City of Ryde Local Planning Panel Meeting No. 9/19

| 1 | 121 Church Street & 19 Porter Street, Ryde - Demolition of a single storey warehouse and construction of a part 4 / part 7 storey apartment building comprising of 1 x studio, 4 x 1 bedroom and 16 x 2 bedroom apartments with basement carparking - LDA2018/0152..... | 3 |
| 2 | 13-15 Farm Street, Gladesville - Construction of a part 3 /part 4 storey residential apartment building containing 21 dwellings over basement parking for 26 vehicles - under the provisions of the State Environmental Planning Policy (Affordable Rental Housing) 2009 - LDA2018/0500 | 133 |

City of Ryde Local Planning Panel Report

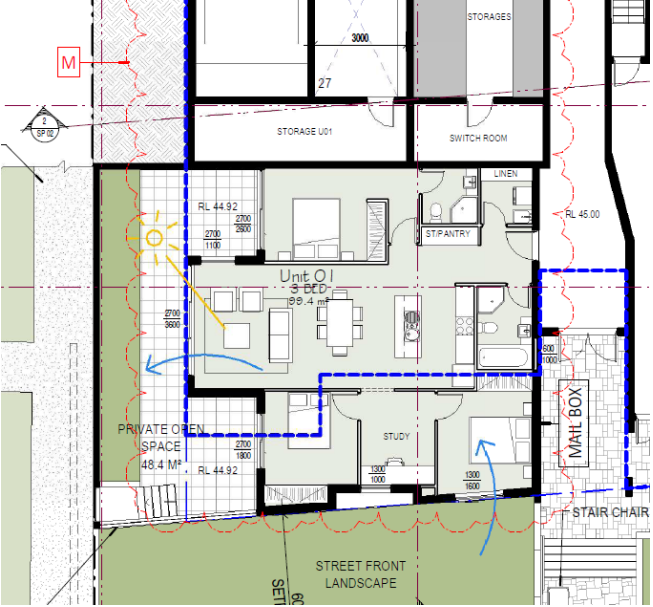
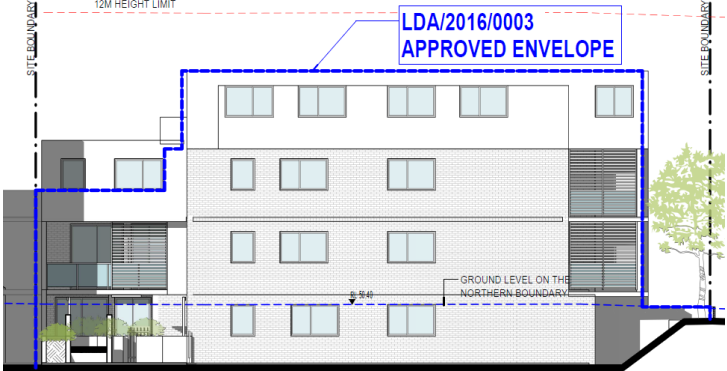
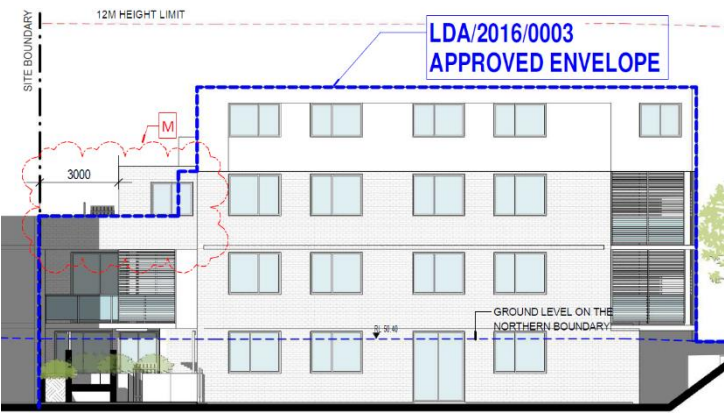
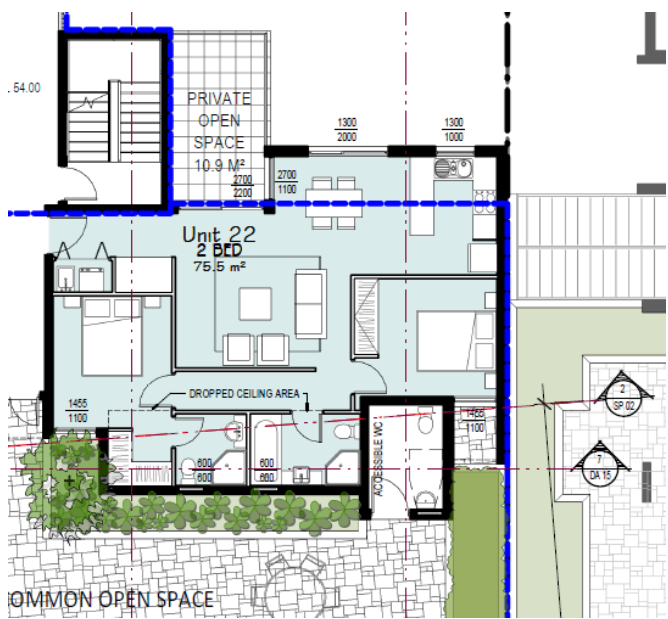
<p>Built Form and Scale</p> <p>Good design achieves a scale, bulk and height appropriate to the existing or desired future character of the street and surrounding buildings.</p> <p>Good design also achieves an appropriate built form for a site and the building’s purpose in terms of building alignments, proportions, building type, articulation and the manipulation of building elements.</p> <p>Appropriate built form defines the public domain, contributes to the character of streetscapes and parks, including their views and vistas, and provides internal amenity and outlook.</p>	<p><u>Urban Design Review Panel</u></p> <p><i>The Panel understands that the proposal now has no exceedances above the LEP height plane.</i></p> <p><i>Consistent with the previous minutes, individual units are discussed here (rather than under “Amenity”).</i></p> <ul style="list-style-type: none"> • <u>Unit 21</u> <i>The previous minutes stated: “Unit 21 is a proposed new unit and has poor amenity with Section 1 and the West Elevation showing that Unit 21 is largely sited below street level. The bedroom for this unit is underground with outlook limited to its undercover terrace. The storage area is of a sufficient area to be used as a bedroom and should be removed from the unit.”</i> <p><i>Unit 21 remains unacceptable in terms of internal amenity, with insufficient daylight access and poor privacy from the street. The store room must be deleted. Swapping the living room and bedroom may provide a better trade-off of daylight between the two spaces, but loss of amenity for the bedroom would result. A better approach would be to re-</i></p>

SEPP 65 – Design Quality of Residential Flat Buildings	UDRP Comments
	<p><i>plan both Units 01 and 21, to locate living areas further to the south towards Farm Street. As well as the “storeroom” to Unit 21, deletion of one bedroom from Unit 01 may be necessary. The current external wall/glazing line along the west side of the building at this (ground) level can also be adjusted – noting the need to manage the architectural design of this corner of the building.</i></p> <ul style="list-style-type: none"> • <u>Units 06, 13, 18, 20</u> <i>These units have their longest external wall facing north but only 700mm high windows, one to the living area and one to each bedroom. From both sustainability and amenity aspects, it would be better to enlarge these openings, with lower sills and higher heads, to let in more daylight and sunlight in winter. With the 6m setback provided from the boundary, ADG compliance is still achieved and no significant privacy problems can be expected. The external area immediately to the north of the living area of Unit 16 should be reorganised so that the fire stair up from the basement is against the boundary and the recaptured external space is allocated to the unit as private open space.</i> • <u>Unit 22</u> <i>The previous minutes stated: “Unit 22 has been added at Level 3. While the addition appears to be in alignment with the height control, there is insufficient information to assess the solar access and privacy impacts on the adjacent property at 11 Farm Street. A part of the living room and the balcony overhangs the building alignment below and creates an awkward built form above the communal open space. The overhang also impacts the solar access to the living area of Unit 12, by increasing the dimension from the building edge to window.”</i> <i>These comments generally stand. No part of Unit 22 should overhang the apartments below, including the outer edge of their balconies (that is, the northern wall of Unit 22 should align with the southern wall of the adjoining fire stair). The current balcony of Unit 22 should be deleted, because it also overshadows some of the bedroom windows to the apartments below and part of the exterior open space. In much the same way that Unit 16 has private open space along its south side adjacent to the rooftop common open space on this level, Unit 22 could have its private open space in this location as an alternative to locating it south of the line of the fire stair wall. There are multiple common open areas and this is a relatively small development, therefore the Panel would accept deletion of the toilet to the common space on this level, with the floor area reallocated to Unit 22. Because of the location of the change in height plane, it appears that the above changes will result in a smaller Unit 22 (studio or one bedroom, as opposed to the current two-bedroom proposal).</i>

SEPP 65 – Design Quality of Residential Flat Buildings	UDRP Comments
	<p><u>Comment</u></p> <p>The following changes were made to directly respond to the matters raised by the UDRP. In making these changes the proposal is now considered acceptable with regard to Built Form and Scale under the ADG.</p> <ul style="list-style-type: none"> • <u>Unit 21</u> <p>This unit was located on the ground level (refer Figure 13) however it has since been deleted in the latest issue of plans (Issue M) (see Figure 14).</p>  <p>Figure 13 - Previous proposed Unit 1 and Unit 21 (Drawing No. 05 Issue K)</p>

Figure 20 - West Elevation Plan (Dwg No. DA11 (M)) showing fence heights outside Units 2 and 8 along The Avenue.

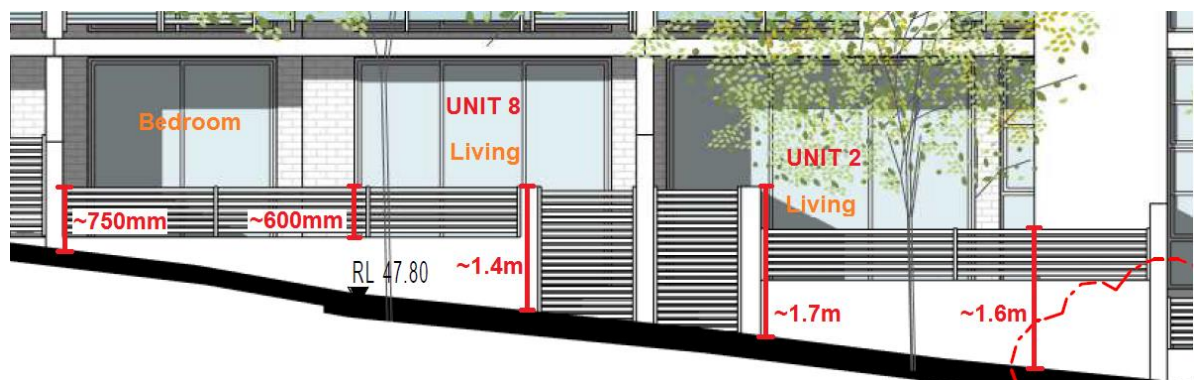
Clause	Comment	Consistent
	of this unit Units, a condition is to be included on the consent requiring the screening of the boundary fence along the front of Unit 8 to be a minimum height of 1.7m which should prevent direct or indirect viewing into these rooms.
